DEPARTMENT REPORT

SUBJECT: SHP-2025-0006
Mogul South

LOCATION: 969 S. La Vista Ln., generally located 1/4 mile east of S. Black Cat Rd. and 3/4 mile south of W. Franklin Rd., in the SW 1/4 of Section 15, T.3N., R.1W. (Parcel #R8956280100)

B. Short Plat (date: 9/25/2025)

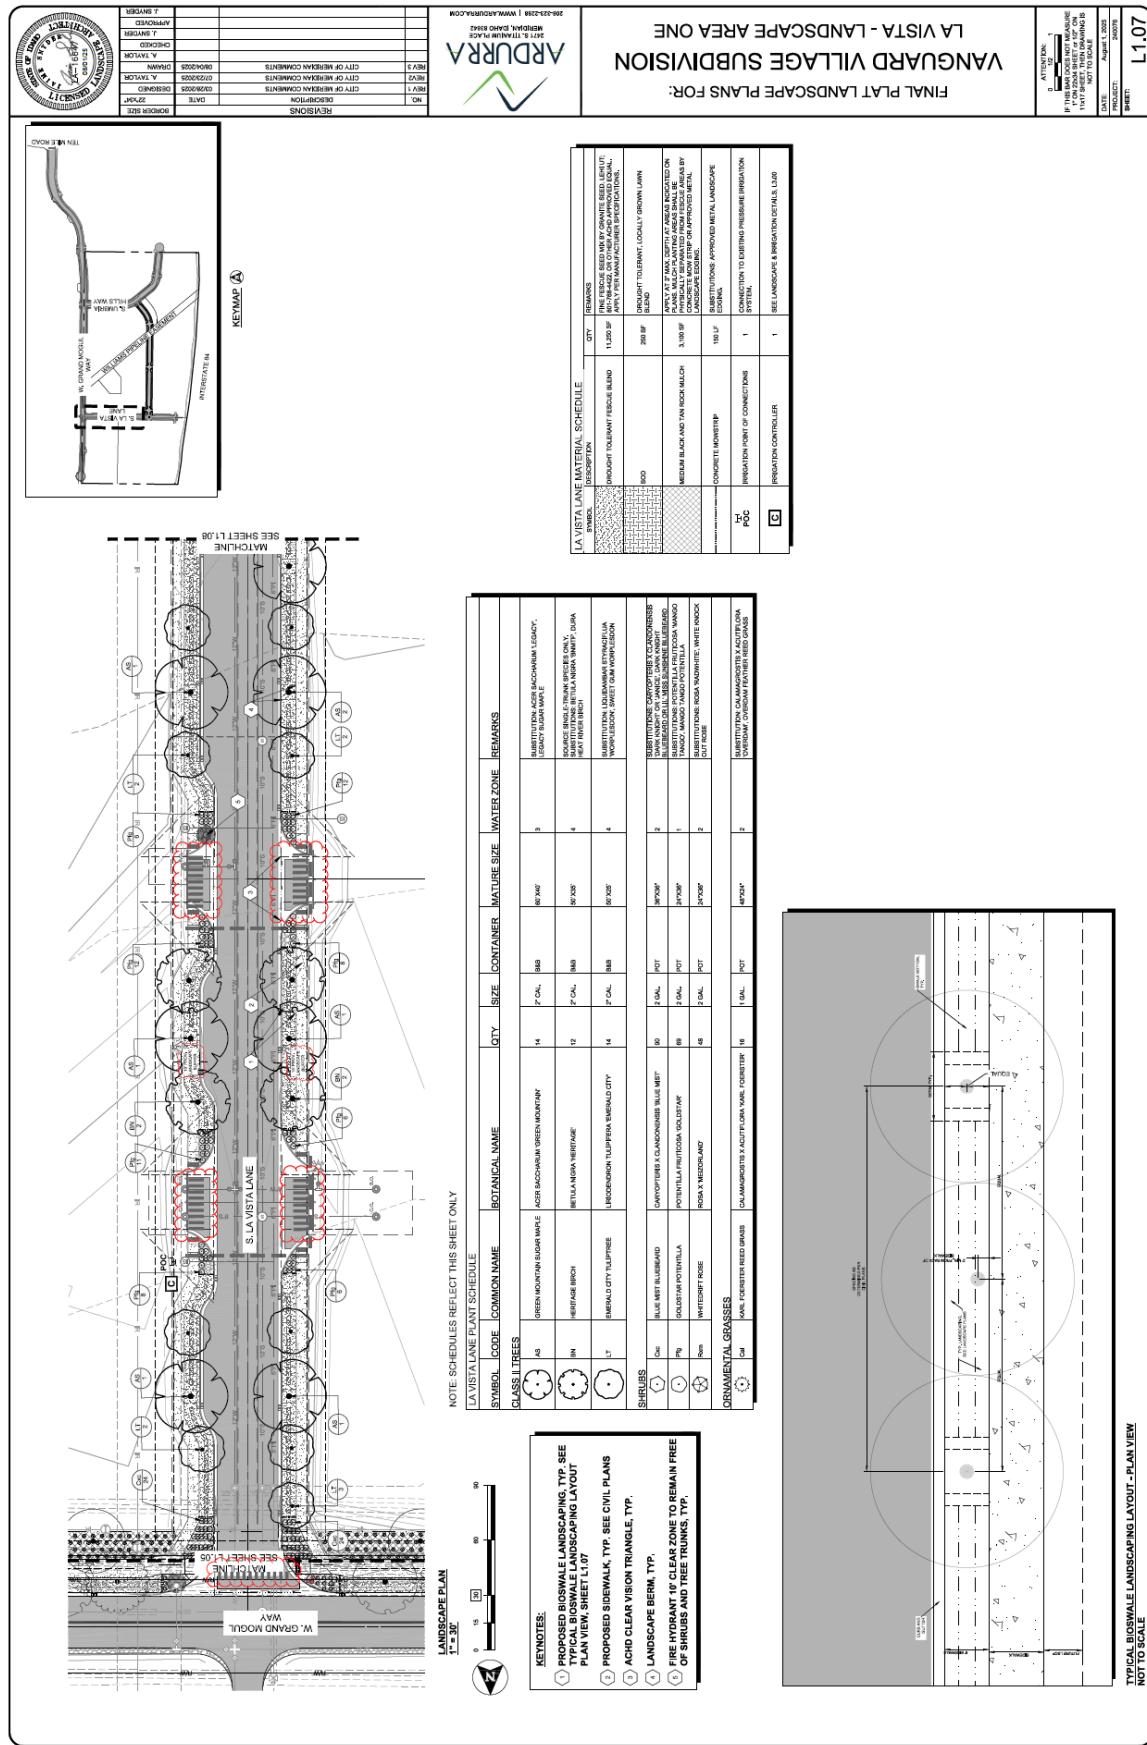
2. Future development shall be consistent with the minimum dimensional standards listed in UDC Table 11-2B-3 for the M-E and H-E zoning districts.
3. The short plat shall include the following revisions:

- a. Include a note granting cross-access easements between both proposed lots for internal cross-access and access via S. La Vista Ln.; or record a separate easement granting such and reference the recorded instrument number in a note on the plat. If parking will be shared between the proposed lots, a cross-parking agreement/easement should also be recorded and/or noted on the plat.

- b. Include a note granting a blanket cross-access easement to the property to the west (Parcel #S1215325450) per UDC 11-3A-3A.2; or record a separate easement granting such and reference the recorded instrument number in a note on the plat.

- c. Note #15: Include the recorded instrument number of the cross-access easement.
4. Street buffer landscaping shall be installed by the developer of Vanguard Village Subdivision No. 1 per the landscape plan approved with that subdivision (FPS-2025-0014), included below in Section VII.C.

C. Landscape Plan Approved with Vanguard Village Subdivision No. 1 (date: 8/1/2025)

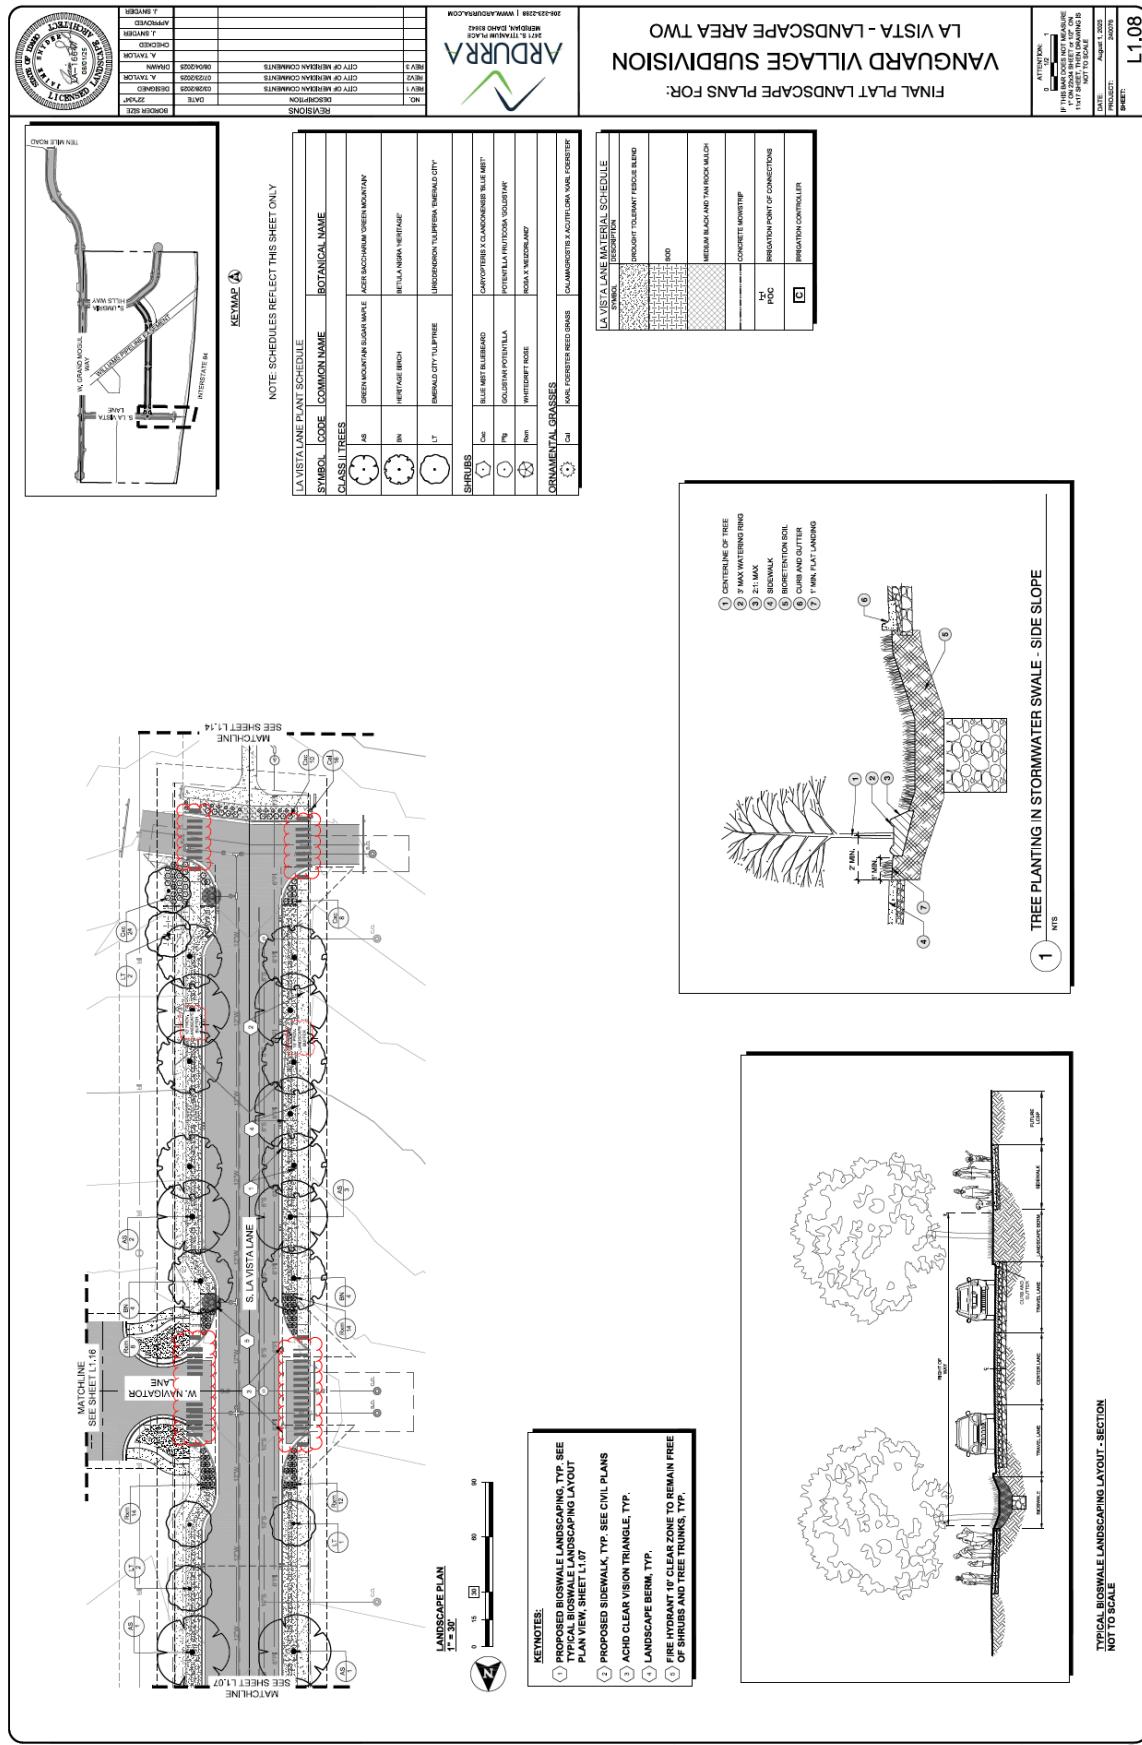
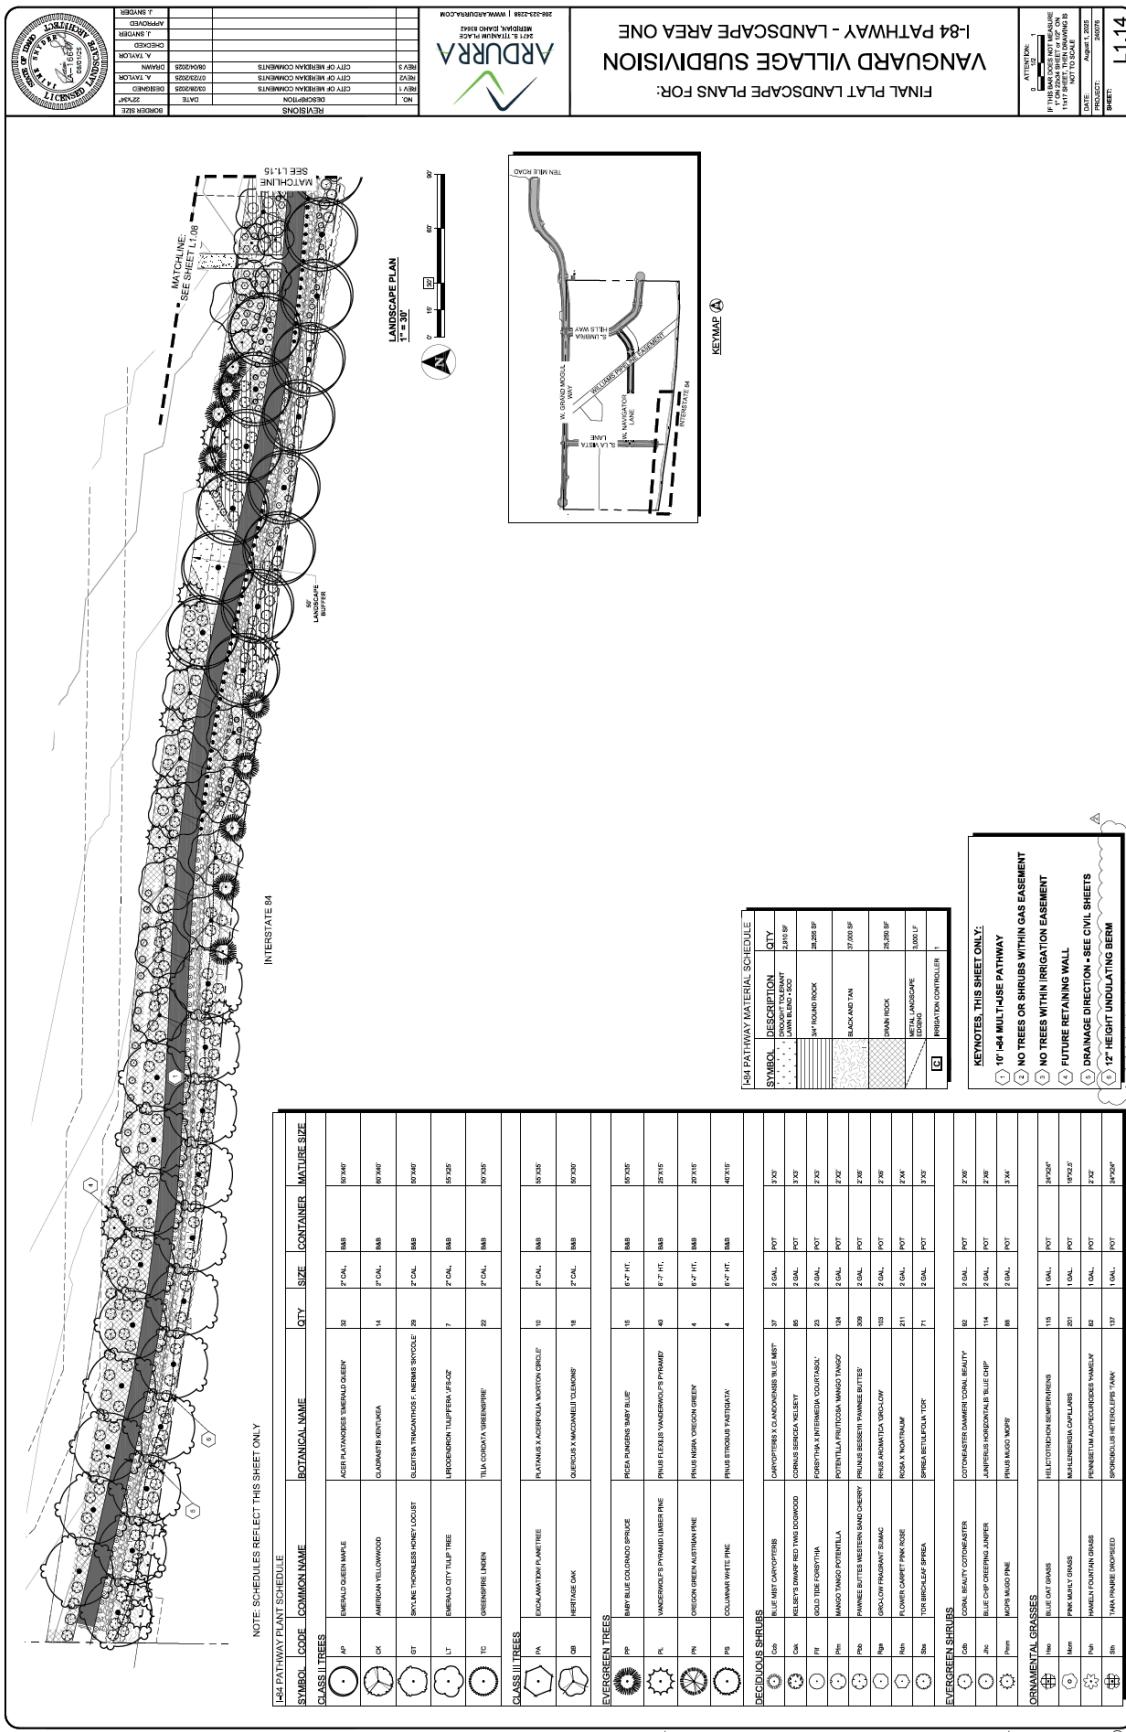
Permanent dedicated buffer easements, maintained by the property owner or business owner's association, are required at the minimum width noted, measured from back of curb. The proposed plat depicts landscape buffers as required. All street buffer landscaping is required to be installed with the subdivision improvements for Vanguard Village Subdivision No. 1 as shown on the approved landscape plan in Section VII.C.
